PETITION NO. 85-144
DATE SUBMITTED 8/22/01
EXHIBIT NO. 4

Alternative Landscape Plan

ALTERNATIVE LANDSCAPE PLAN JUSTIFICATION SUPPLEMENTAL APPLICATION

Mars Music Amphitheater® the So. Florida Fairgrounds VIP Parking Lot Palm Beach County, Florida

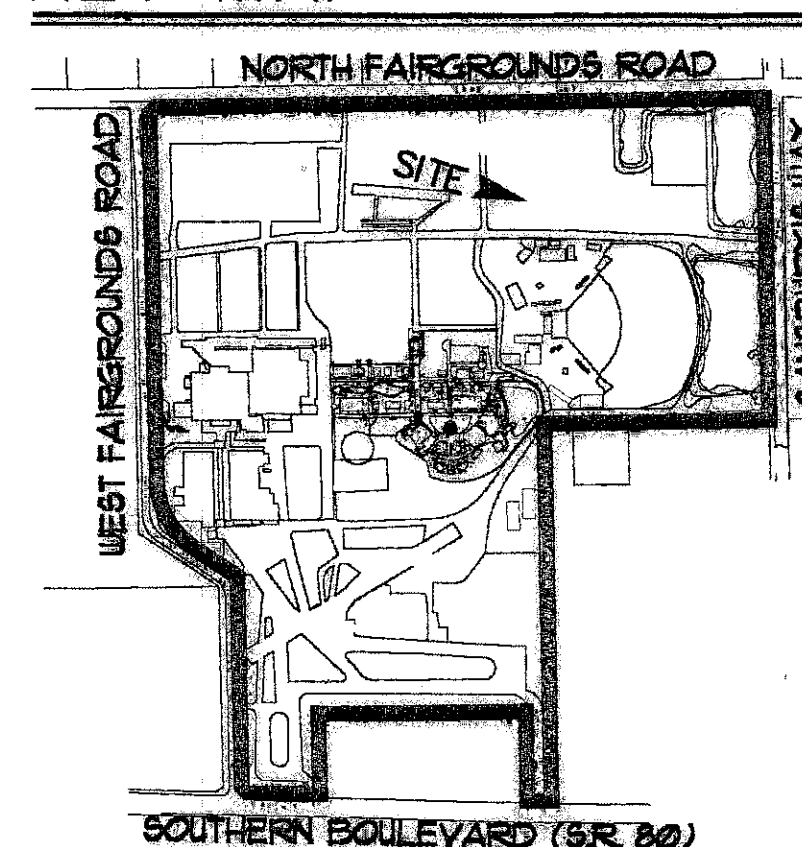
The Zoning Division has reviewed your Alternative Landscape Plan and is recommending approval. The proposal deviation from the literal intent of the landscape code is as follows:

- ULDC Code Section 7.3.G.3.a(2), requires one interior island with tree per every twelve parking spaces. The Alternative Landscape Plan proposal is to relocate 17 trees required in the interior islands to the perimeter of the parking lot. The relocation of these 17 trees plus the increase in size from ten foot to fourteen foot, along with the addition of nineteen (19) sabal palms, twelve (12) Ligustrums, and one hundred sixty-six (166) shrubs to the perimeter of this parking lot will allow for greater flexibility to the users by accommodating a variety of vehicle sizes. The trees relocated and added along with additional shrubs to the perimeter will be providing buffering from the parking lot to other uses on site.

The proposed adjustments to the placement, size increase and additional palms to the landscaping will allow Mars and the Fairgrounds for flexibility in parking for, VIP box and season ticket holders, staging area for four buses, RVs, limo's and visitors of the various fairground facilities. The use of larger Live Oaks in the terminal islands and the buffers, increased size of four terminal islands to 18'x36', plus additional Royal Palms, Sabal Palms, and Medjool Palms, justifies staff's support. The change also allows for pedestrian pathways to facilitate access for when the lot is used for parking.

Conditions of Approval:

1. Prior to DRC certification of the Alternative landscape Plan, the applicant shall ensure the Justification Statement and Staff's Comments are attached to the plan. (DRC)

2. By December 10, 2001, the applicant shall submit for the permit of the parking lot (paving and drainage permit), at which time a copy of the Alternative Landscape Plan shall be submitted as part of the permit application. (MONITORING, LANDSCAPE)

3. Any modifications to the Site Plan that are not consistent with the Alternative Landscape Plan reviewed as part of this submittal, shall receive approval from the Landscape Section. (DRC-LANDSCAPE)
